ANSEMI ACRES

Improvement Plans

Anselmi Acres Subdivision
WEBER COUNTY, UTAH
Cover/Index Sheet

Sheet Index

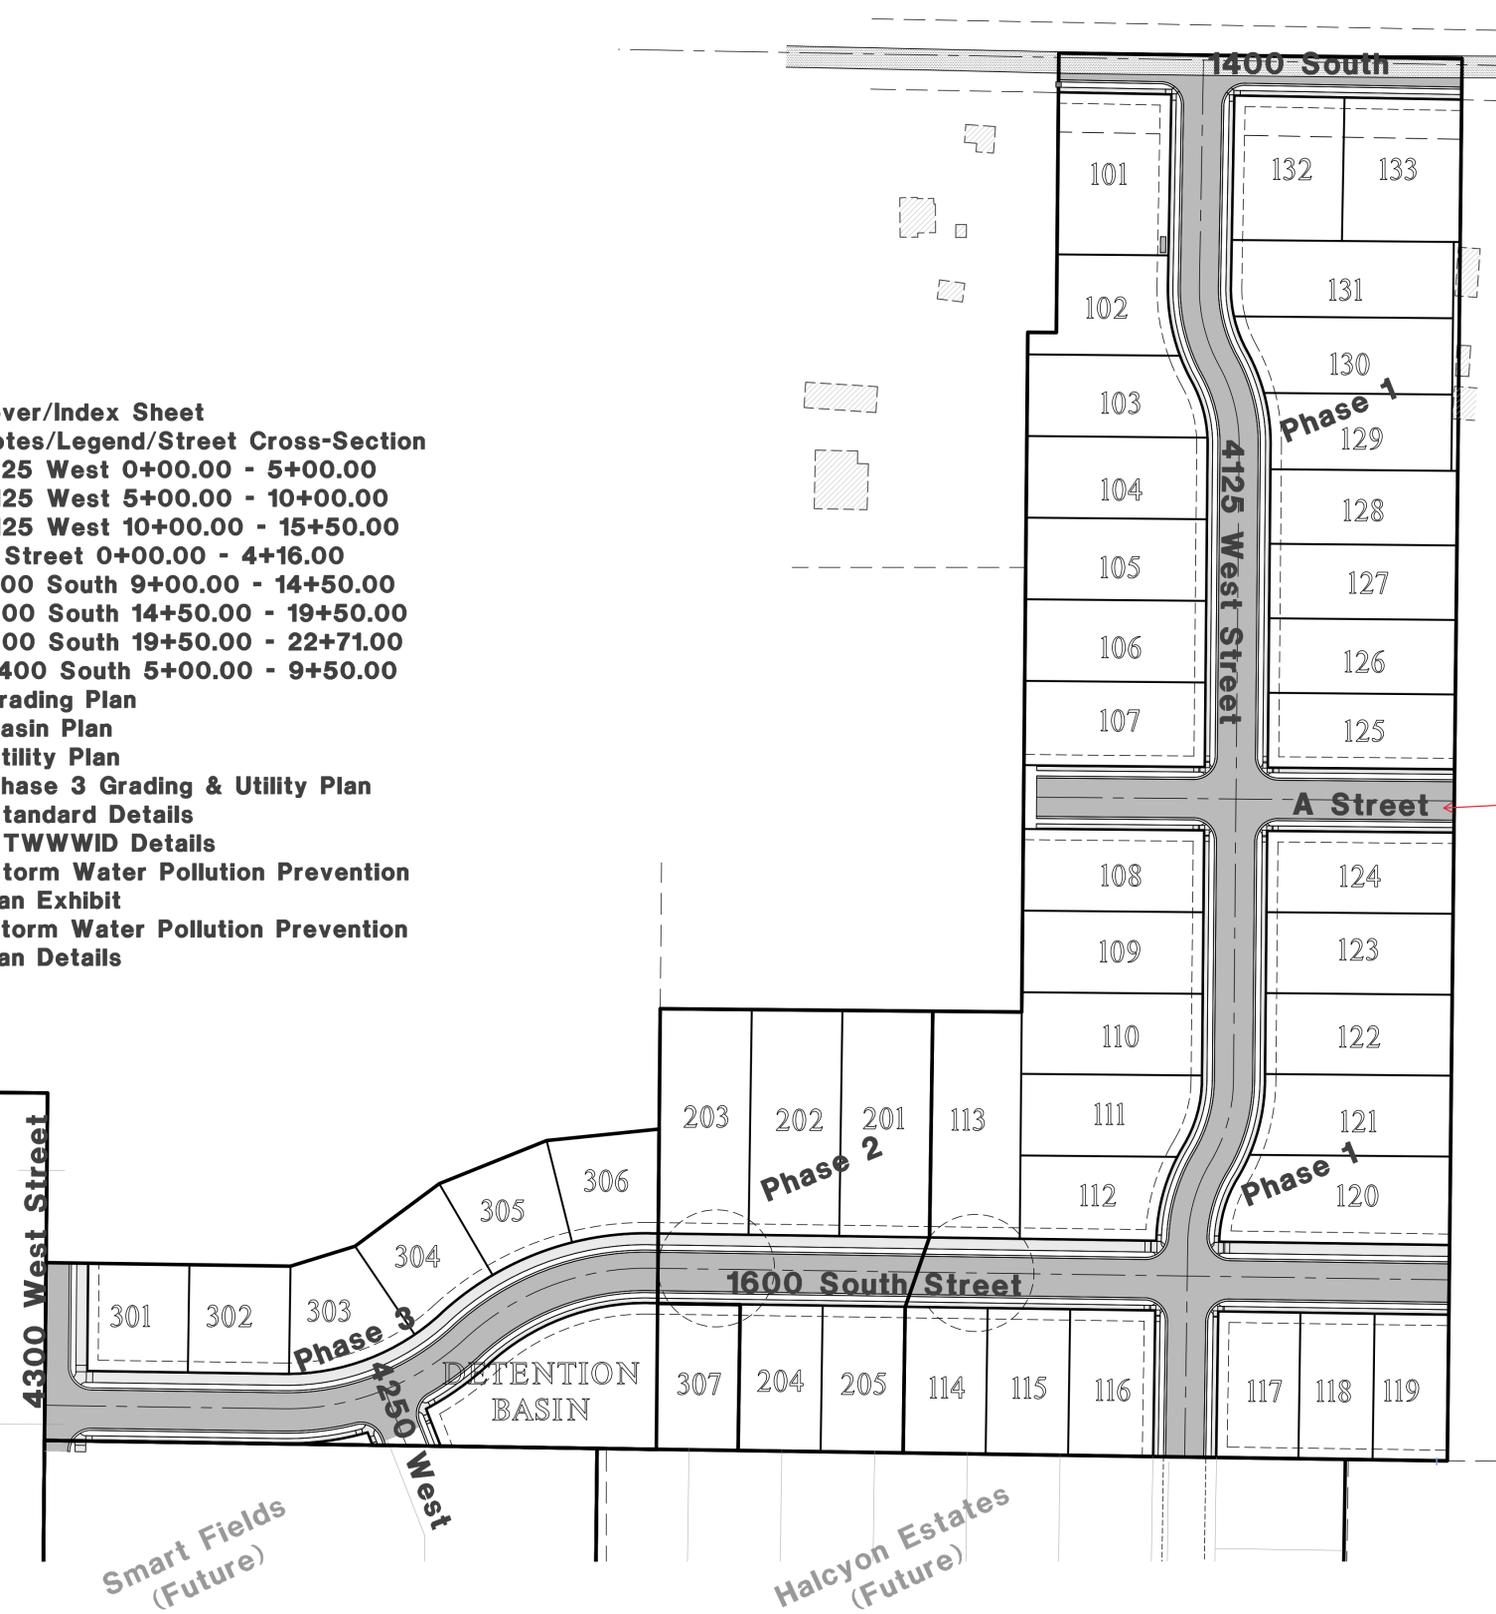
What street is this?

4125 West 10+00.00 -14+00.00

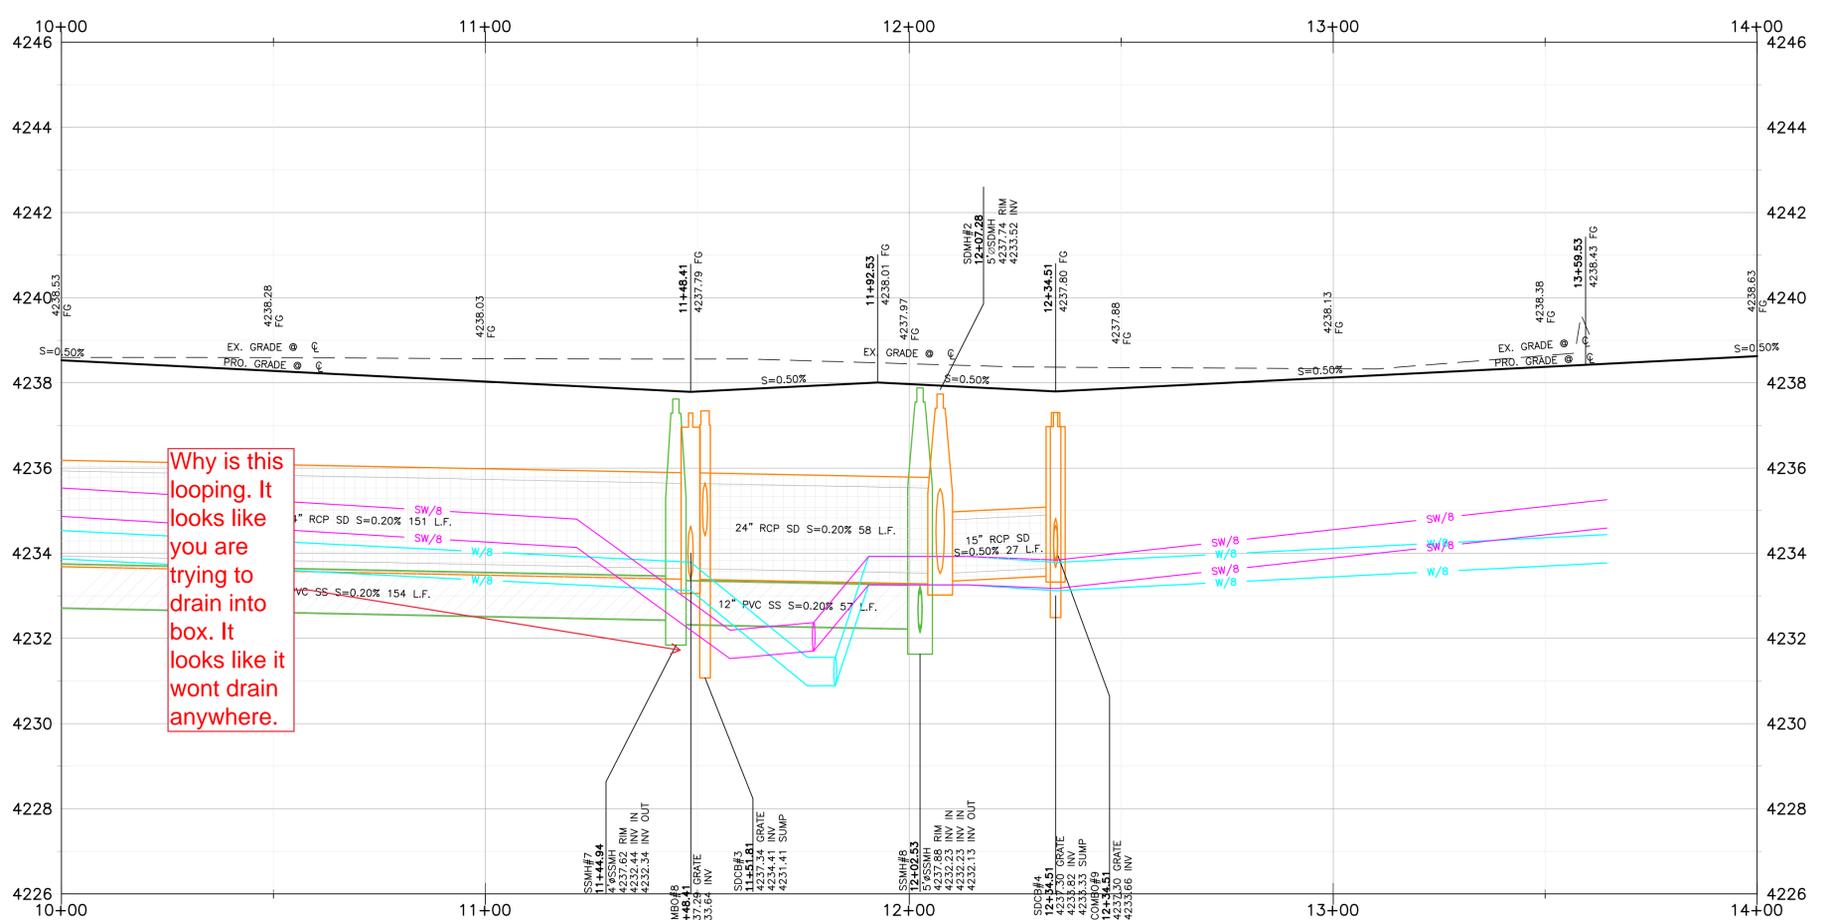
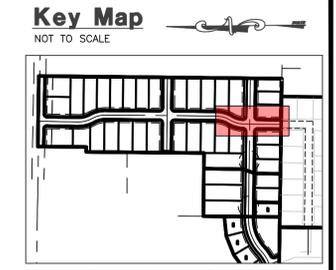
Why is this looping. It looks like you are trying to drain into box. It looks like it wont drain anywhere.

A Street 0+00.00 - 4+16.00

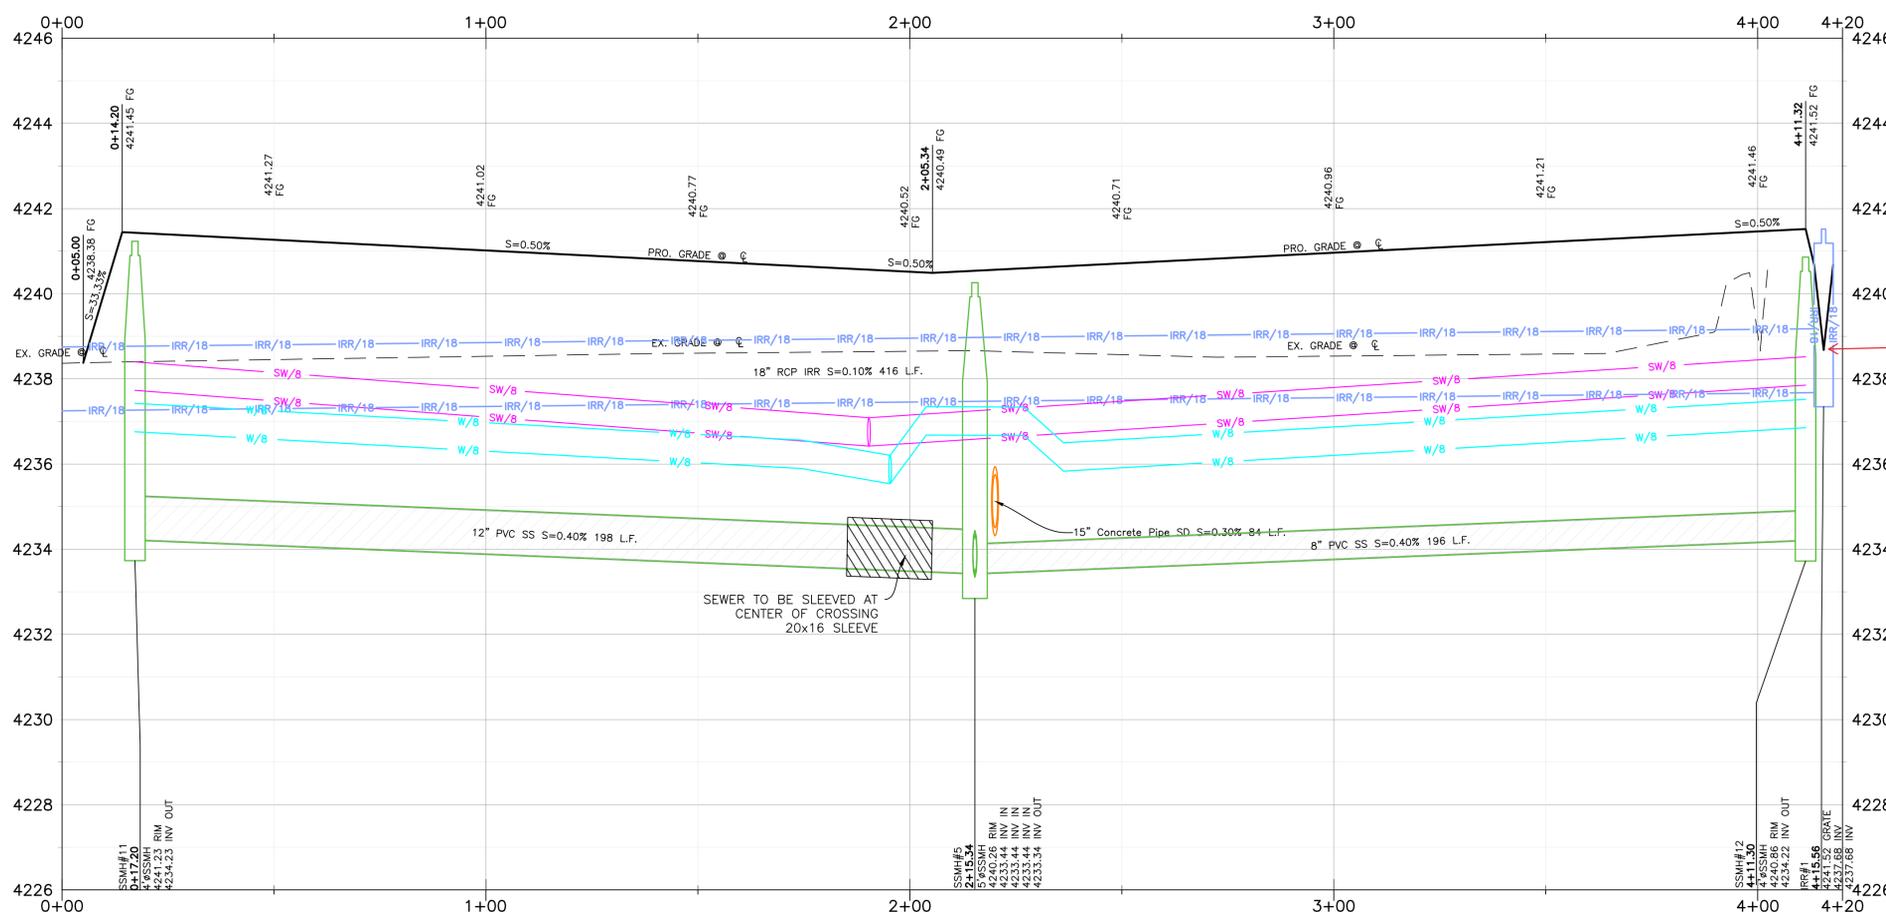
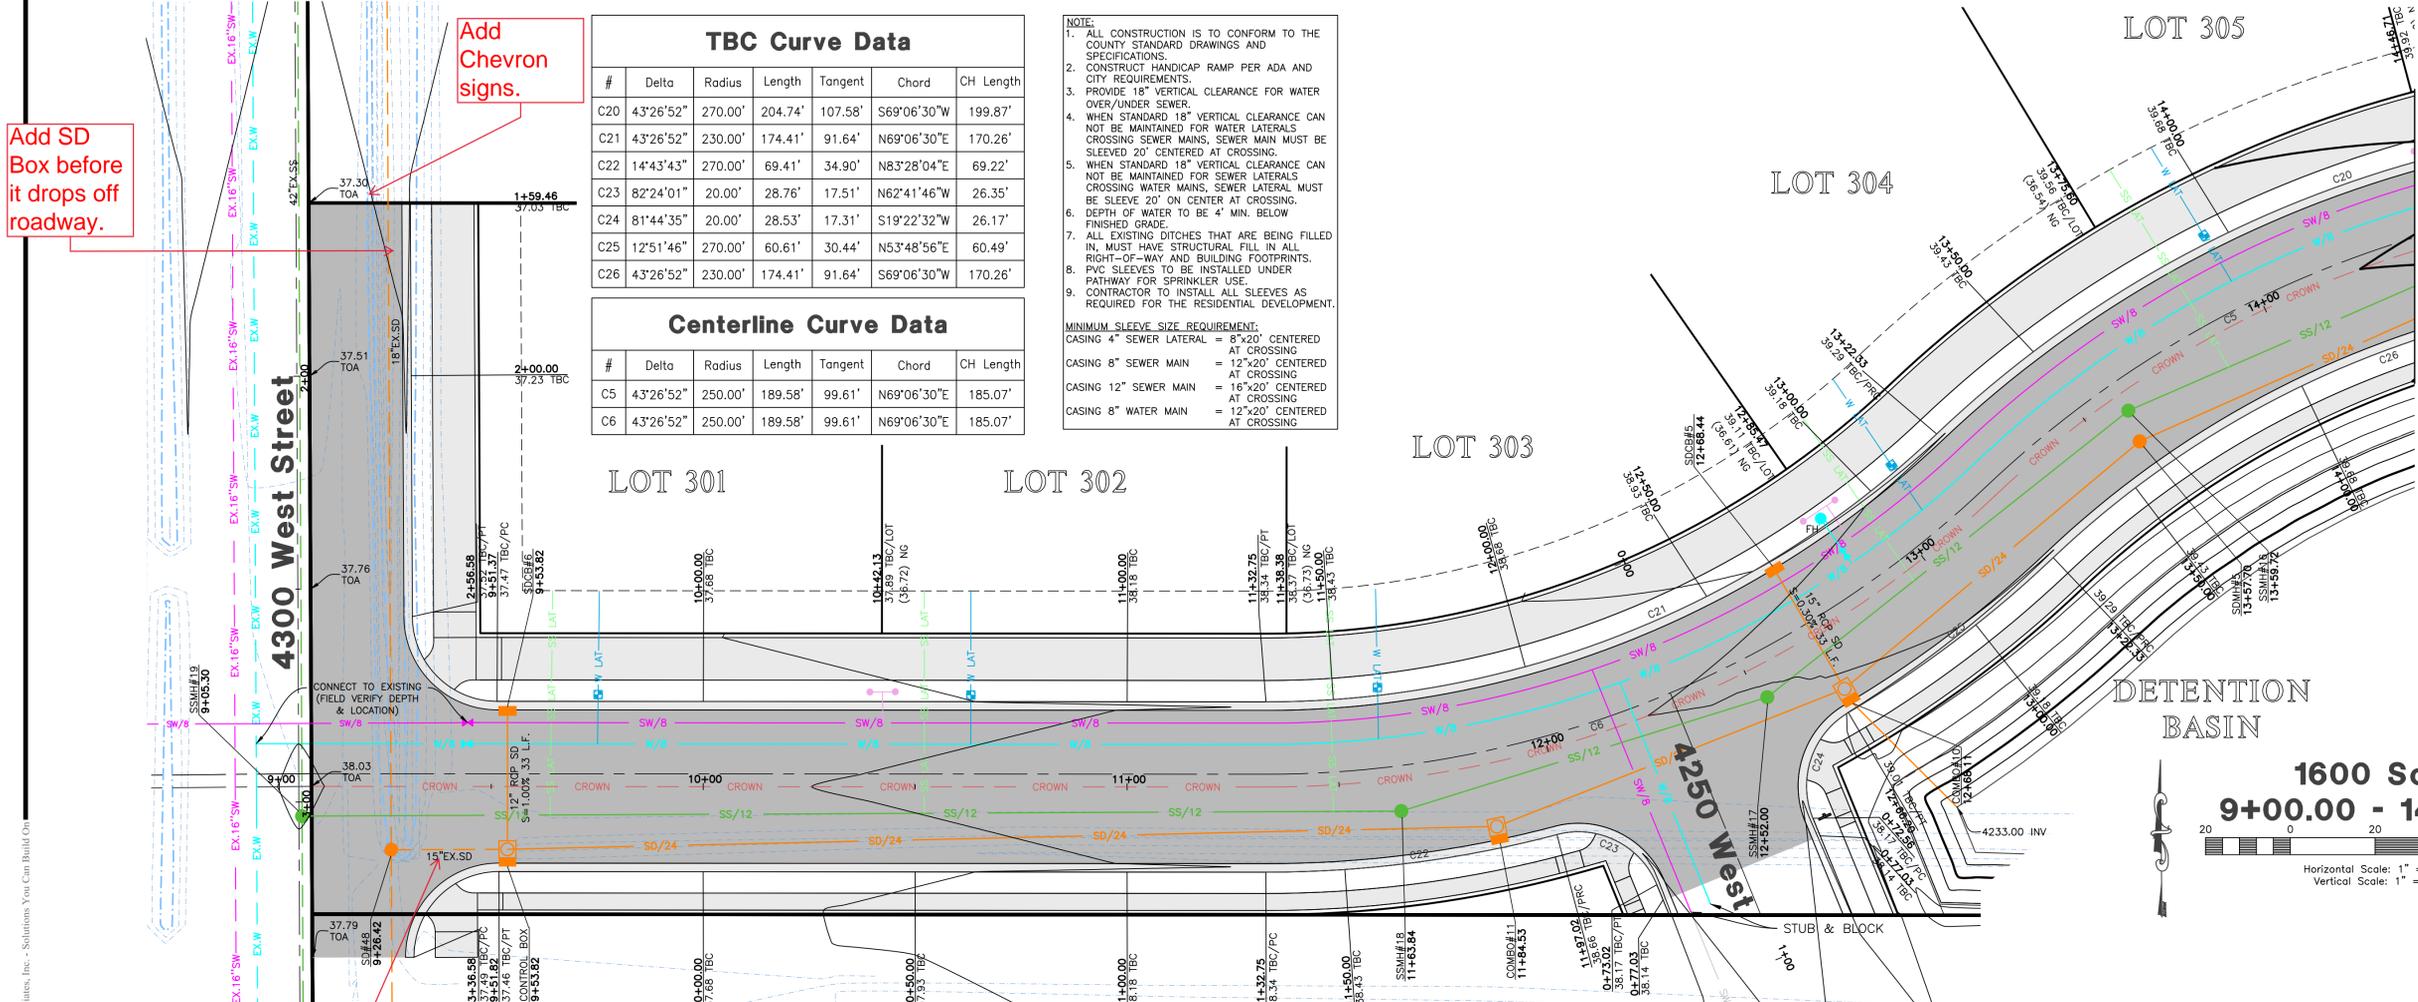
Details on this box?

1600 South 19+50.00 - 22+71.00

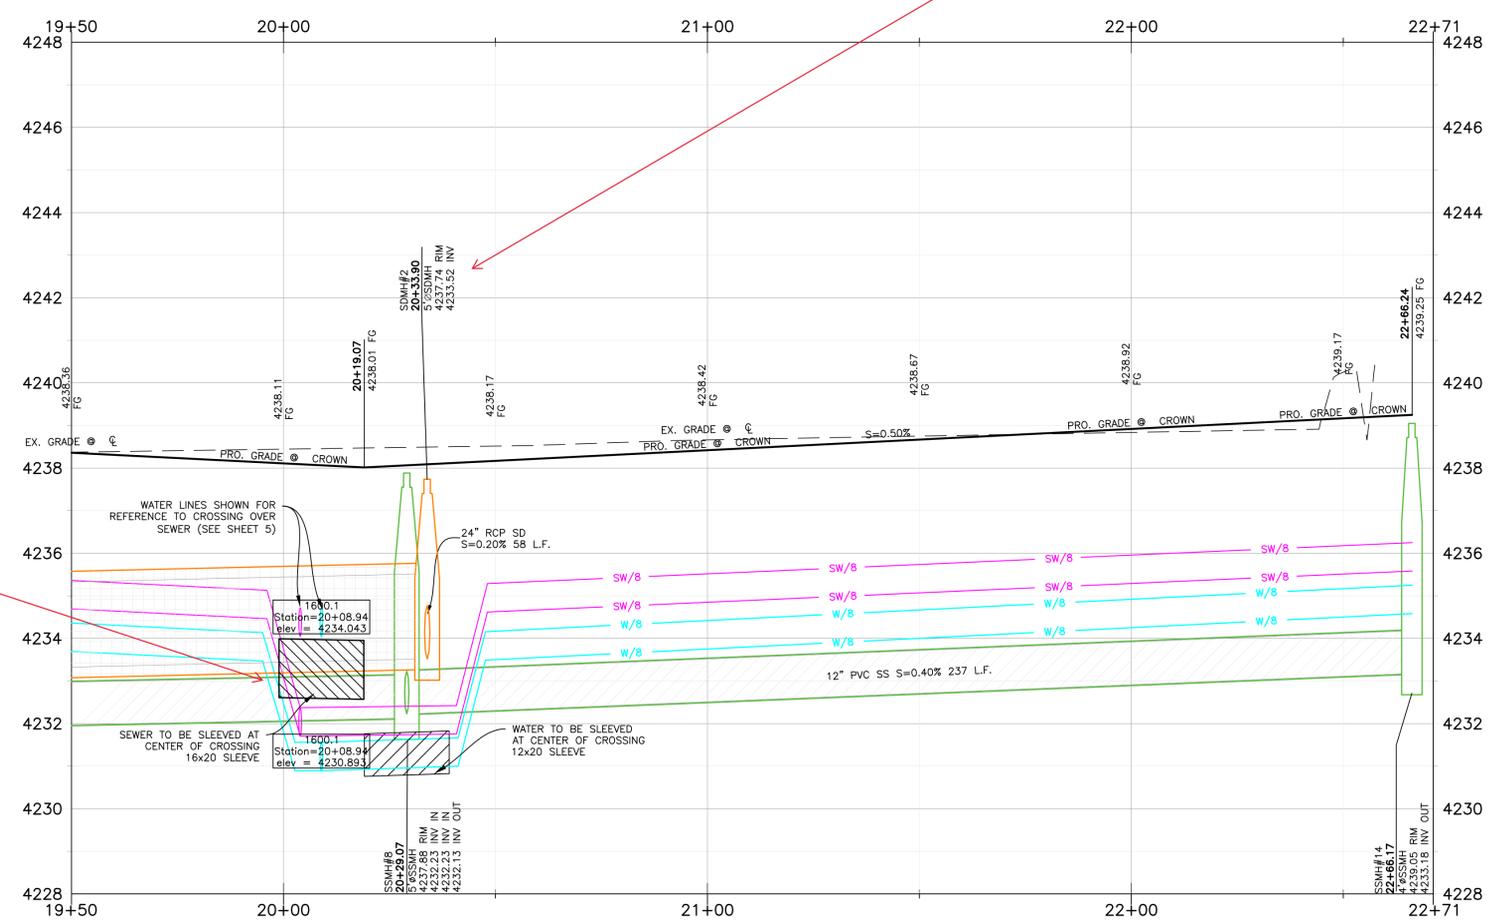
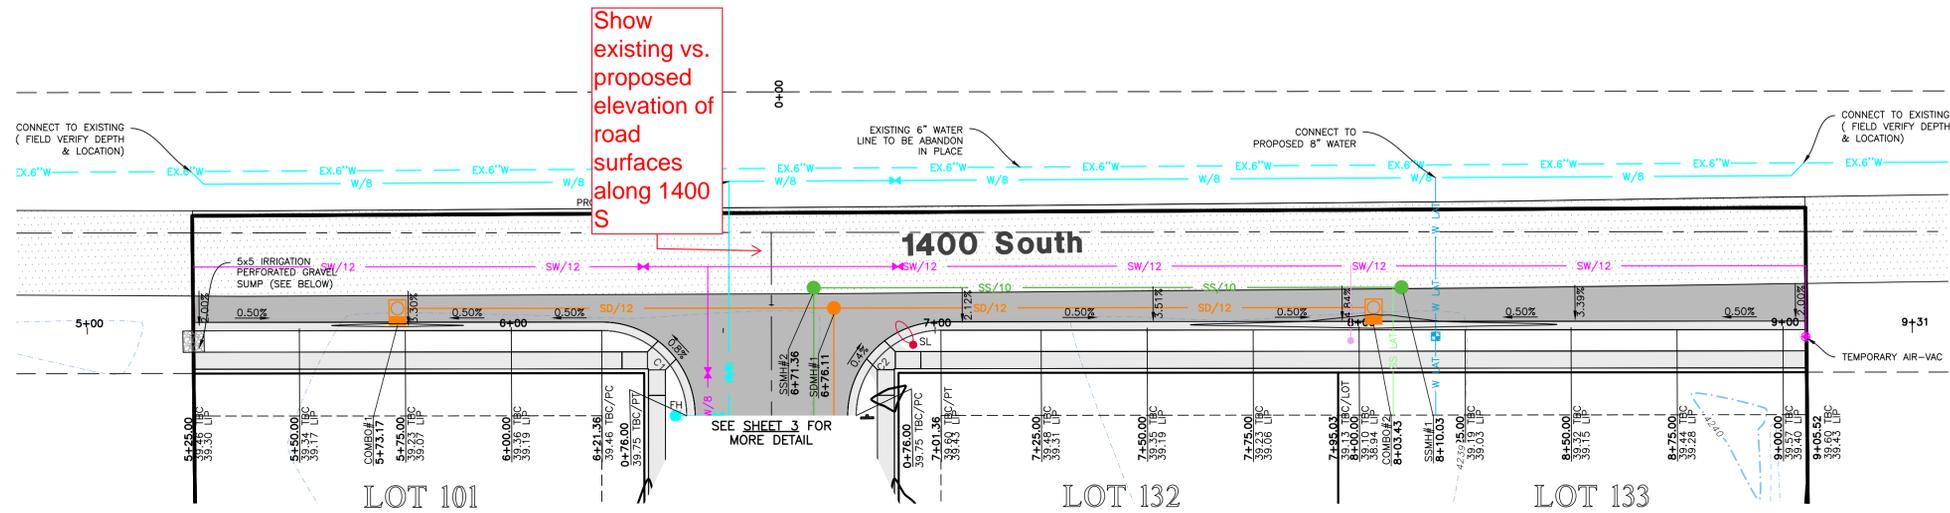
Add a In/Out invert elevation on all SD boxes.

This looks off where the sleeving is.

Local Drain w/ Sump
 SCALE: NONE

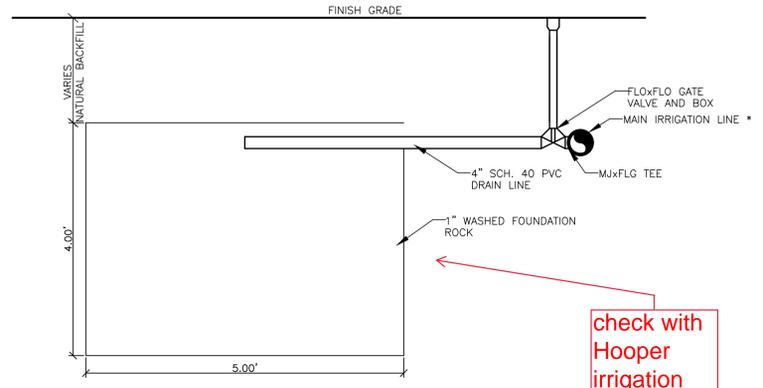
check with Hooper irrigation for this drain? Can it be taken to the SD ditch on north side or road?

pipe size minimums are 15"
